To:	Jerry Graham, Doug Fielding, Calvin Goldschmidt, Greg Blaylock	Date:	August 24, 2011
Company:	JDS	From:	Iozsef Miskolczi
Copy to:	Maritz Rykaart, SRK Lowell Wade, SRK	Project #:	1CH008.033.0350
Subject:	Site Directive for Sump Detail of Primary Vent Raise

DORIS NORTH PROJECT

Fuel Tank Containment
Typical Sump Detail

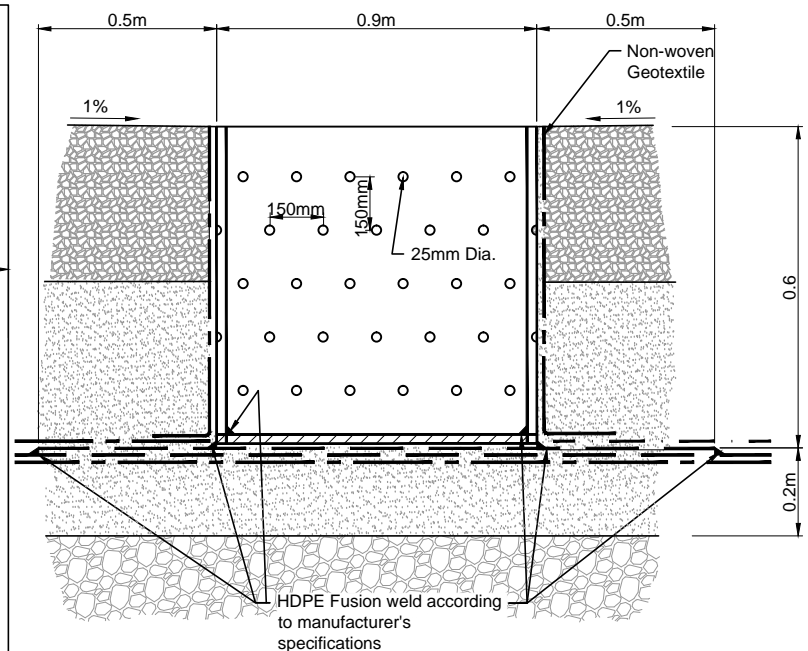
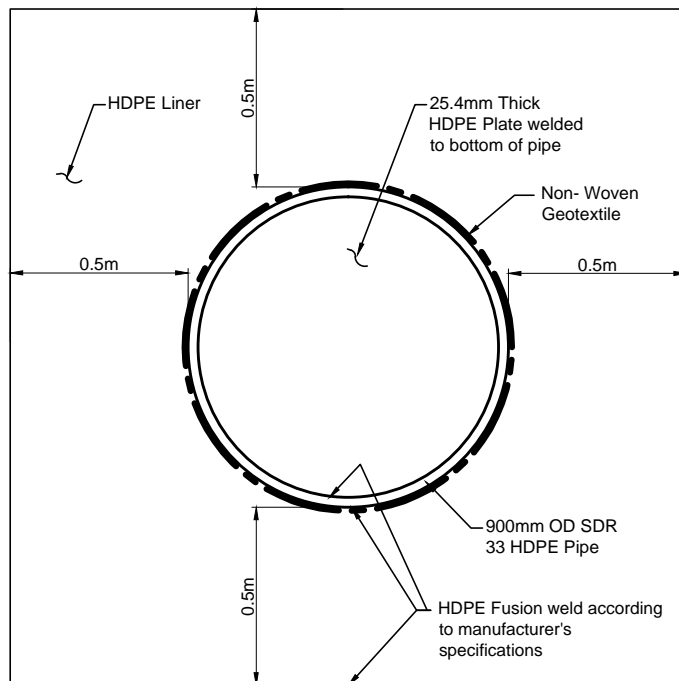
The IFC drawing package detailing the Primary Vent Raise construction does not contain details for the collection sump within the Fuel Containment Area. Also, the floor of the containment area shown on drawing DN-PVR-04[HB+D-CIV-CIV-OND-0136] is flat.

To achieve the required 1% minimum drainage grade within the Fuel Containment Area, the location of the sump will be staked out as shown in the Fuel Tank Containment Berm Stake Out Table, except the elevation will be set at 48.25 masl. The crush cover within the footprint of the sump will be cut to match this elevation, while the remaining floor surface of the Containment Area will be regraded from the perimeter toward the sump to match the staked-out elevations. The elevation of the floor perimeter is to remain as is.

Figure 1 shows the Typical Detail of the sump that should be read in conjunction with the Fuel Tank Containment Liner Plan shown on drawing DN-PVR-04[HB+D-CIV-CIV-OND-0136] associated with the Primary Vent Raise Pad drawings package.
